Re : Rathborne 725 Block A – Pelletstown, Ashtown, Dublin 15
Block A Substation LRD Amendments

**Re: Design Submission for 11 Acres Site, Rathborne Development, Ashtown, Dublin
(the “Development”)
(the “Design Submission”) / Connection Reference No: CDS23005976**

**Our Ref: CDS23005976 Pre-Connection Enquiry
11 Acres Site, Rathborne Development, Ashtown, Dublin**

| Rev | Date | Description | By | CHK |
|--|------|-------------|----------|-------------------|
| Title: DRAINAGE GENERAL ARRANGEMENT | | | | |

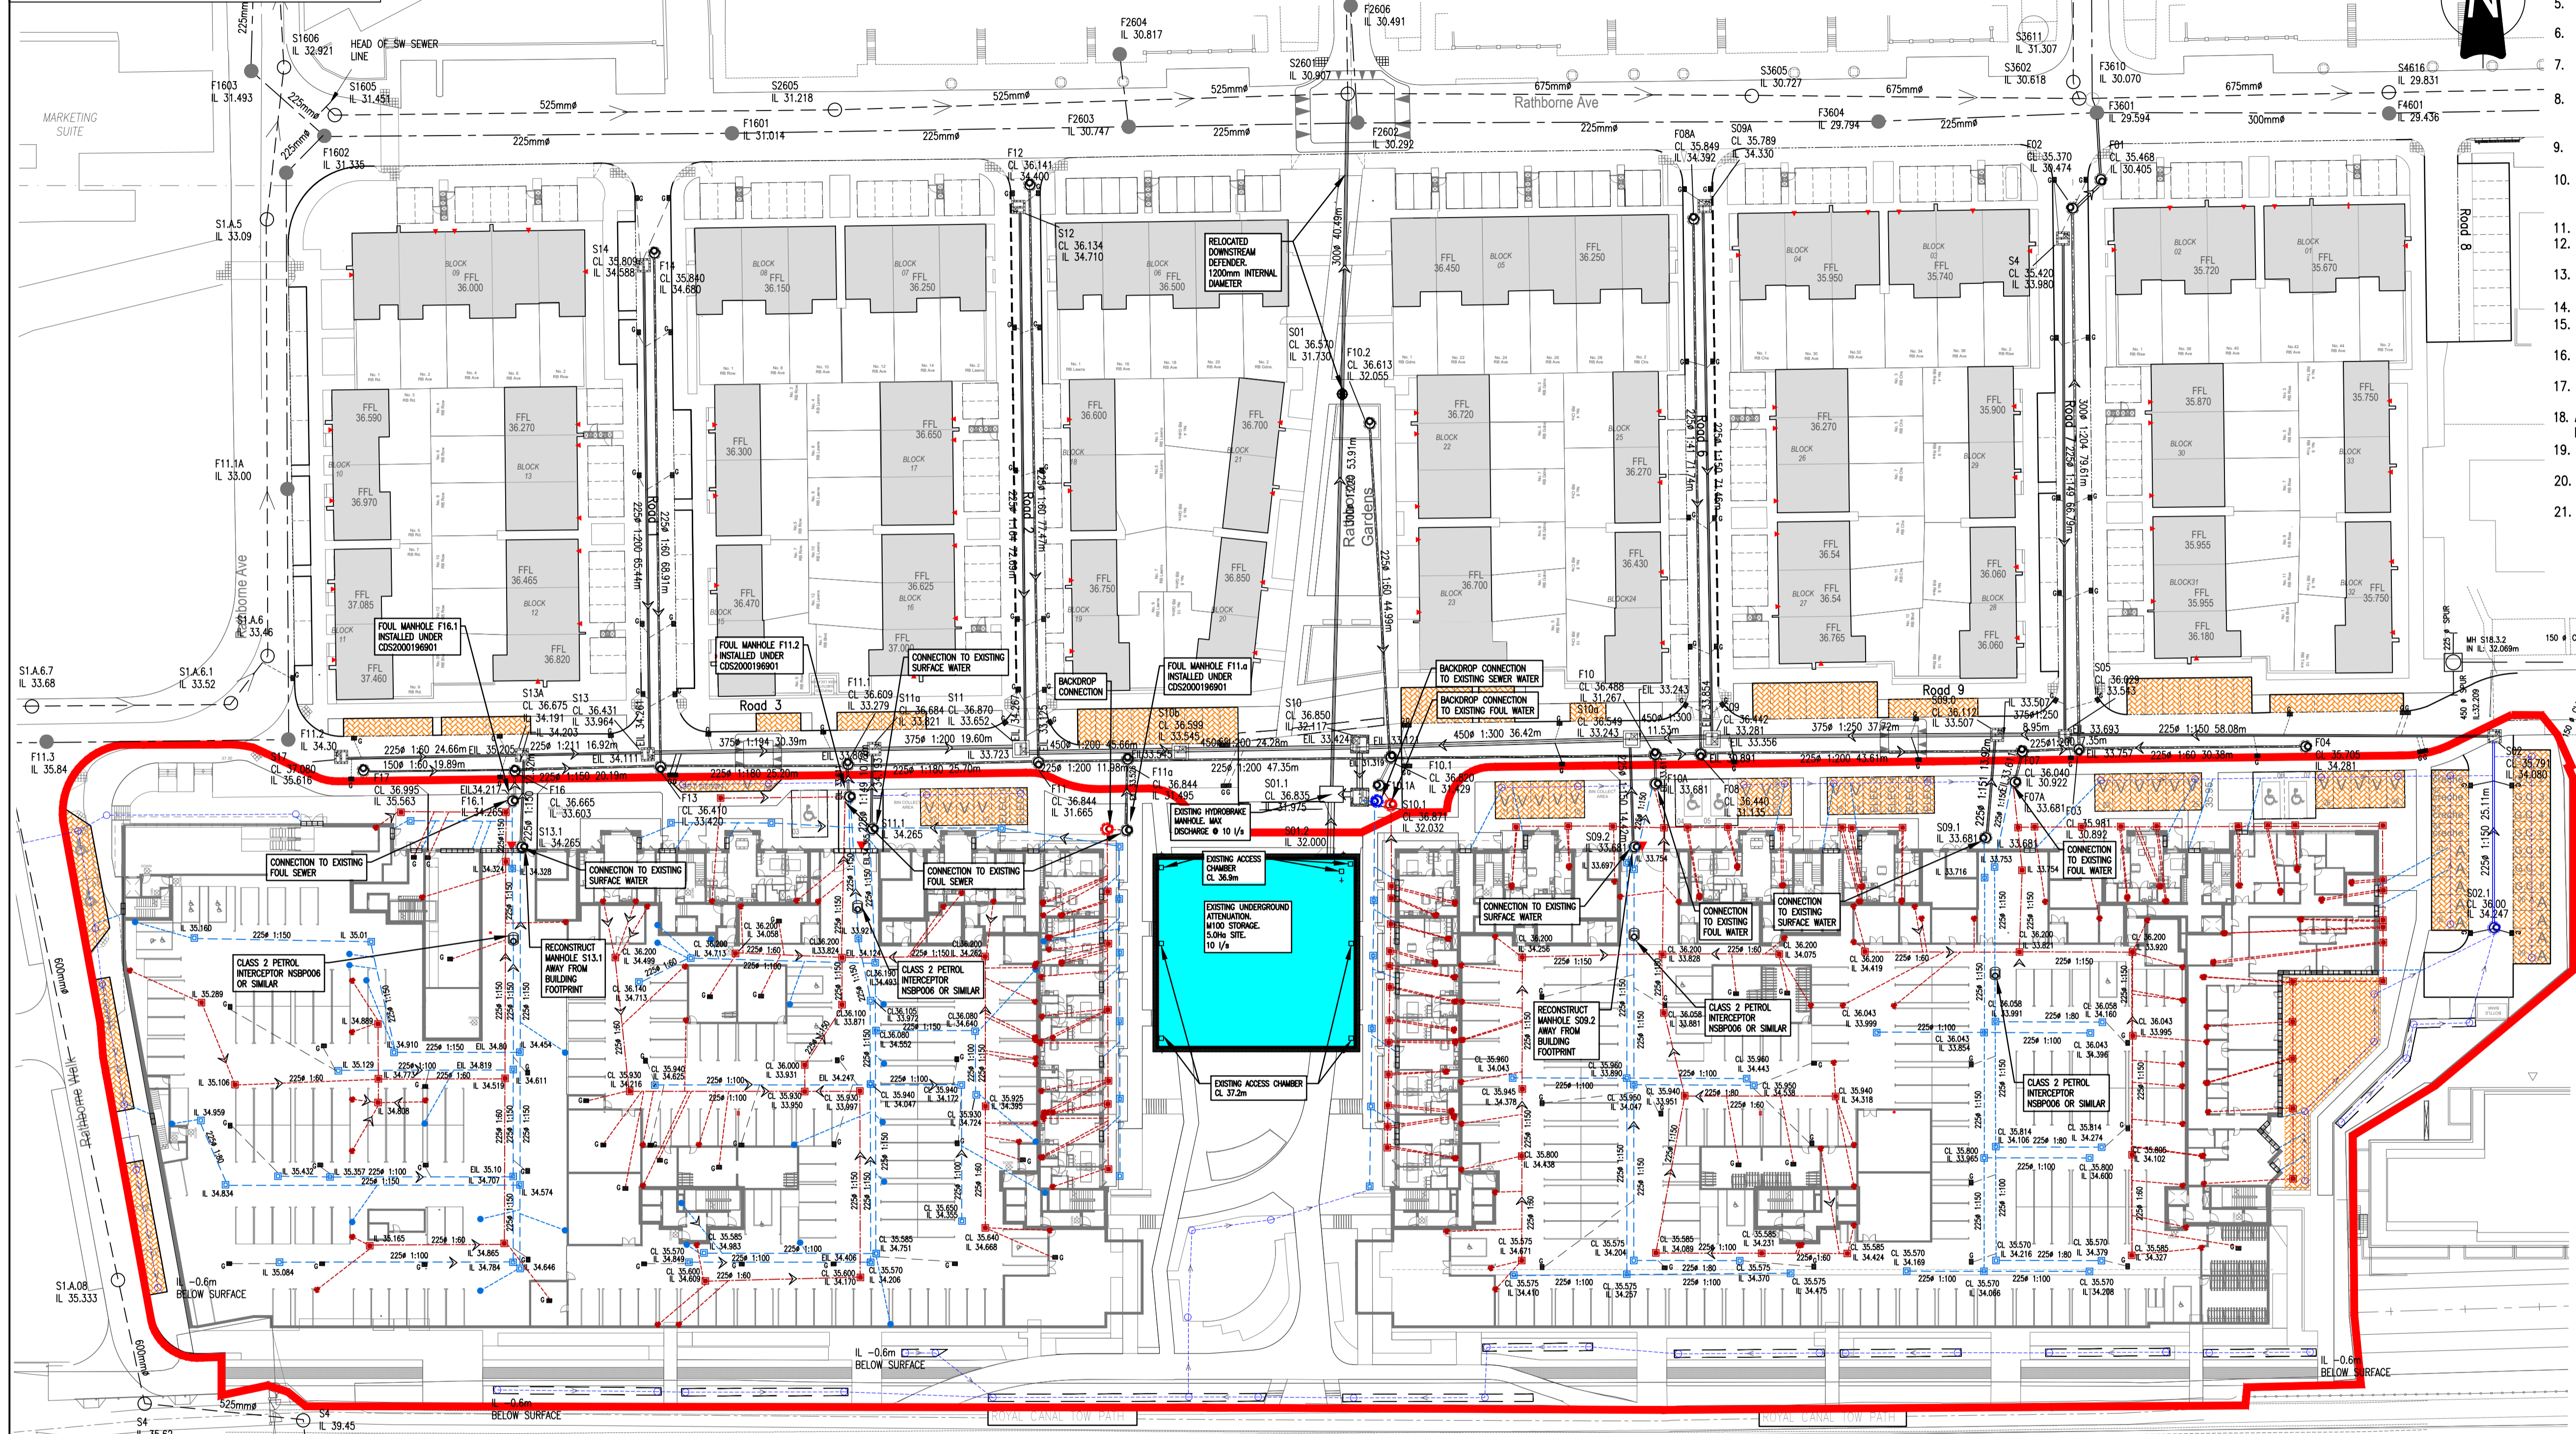
The design submission will be subject to further technical review at connection application stage.

Uisce Éireann cannot guarantee that its Network in any location will have the capacity to deliver a particular flow rate and associated residual pressure to meet the requirements of the relevant Fire Authority, see Section 1.17 of Water Code of Practice.

While Uisce Éireann notes that the sections of the wastewater services infrastructure will remain private and not be vested, we have the following comments: It is recommended that the foul sewer shall have 3 m clearance from proposed or existing structures.

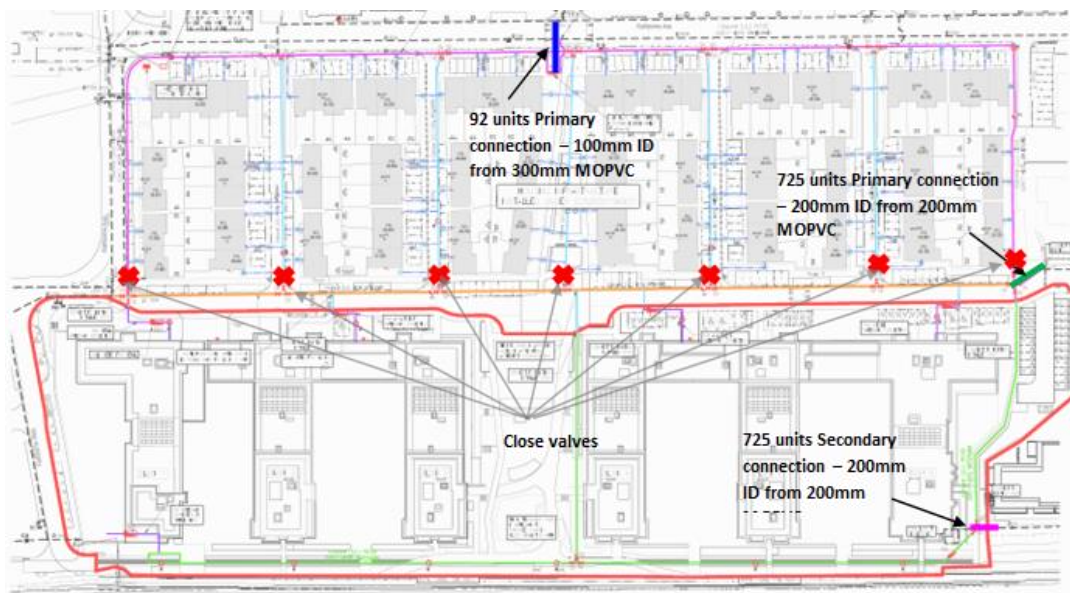
Two connection options are proposed:

1. Common connection (houses and apartment units)
 - The 200mm ID primary connection to be taken from the east from 200mm MOPVC and two nos. of 200mm ID secondary connections, one from North (300 MOPVC) and another one from South-East (200 MOPVC) – Refer to Figure 1
 - Meters to be installed on all three connection mains. The secondary connections will remain closed during normal operations.

2. Separate connection (apartment units)

- Two primary connections: 100mm ID from 300 MOPVC in the North for 92 units and 200mm ID from 200mm MOPVC in the East for 725 apartment units
- One secondary connection: 200mm ID from 200mm MOPVC in the South-East
- Close the valves (x) connecting houses and apartment blocks.
- Meters to be installed on all connection mains. The secondary connection will remain closed during normal operations.
